Application Note AN-1100

IRS211(0,3) and IR211(0,3) Comparison

Figures

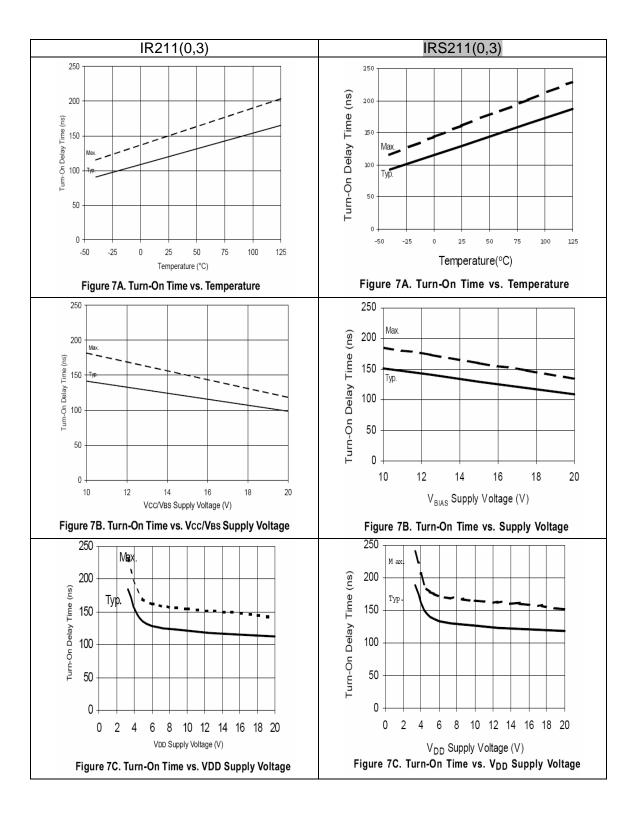
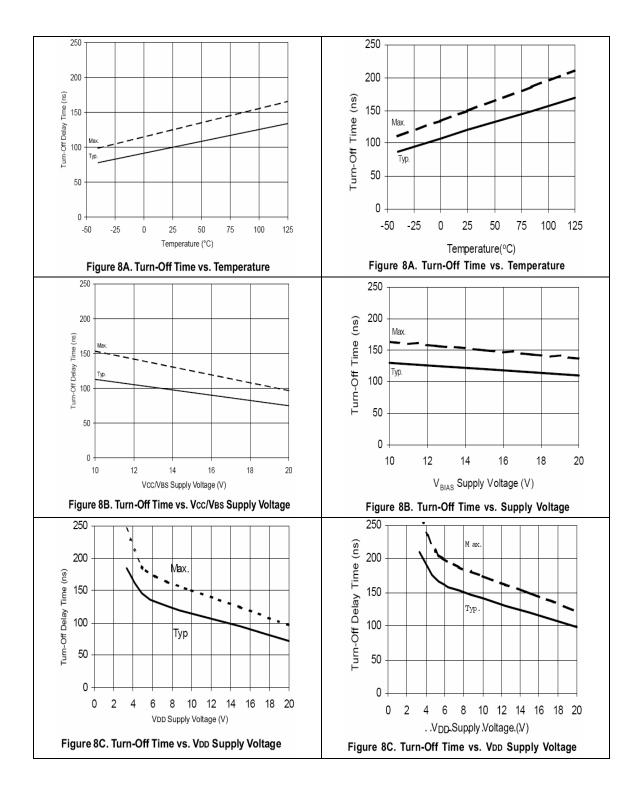
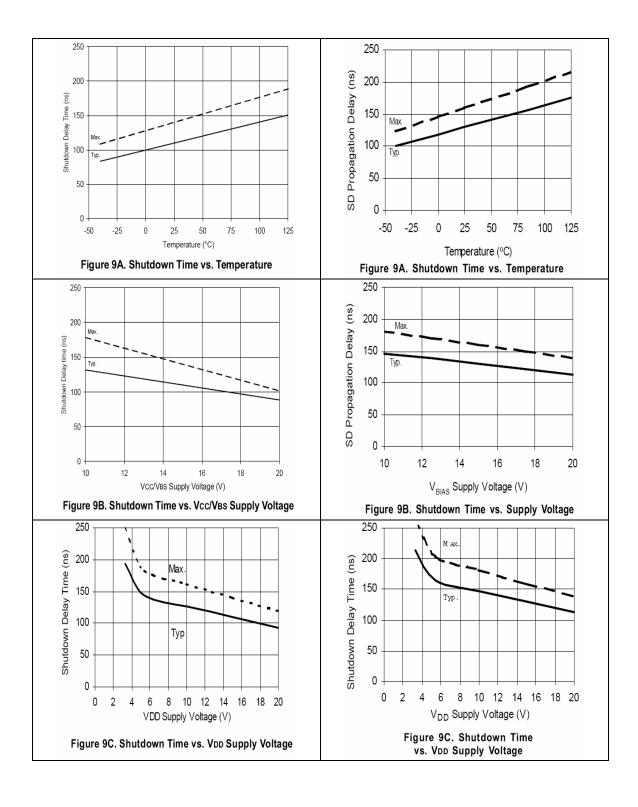
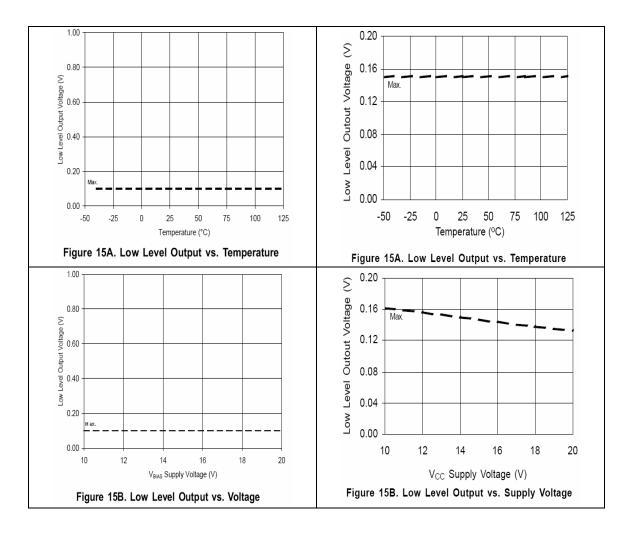
This figures shown in this section compare figures shown in the IR211(0,3) (left column) and IRS211(0,3) (right column) datasheets. Illustrations that have not changed between the two datasheets have not been included in this section.
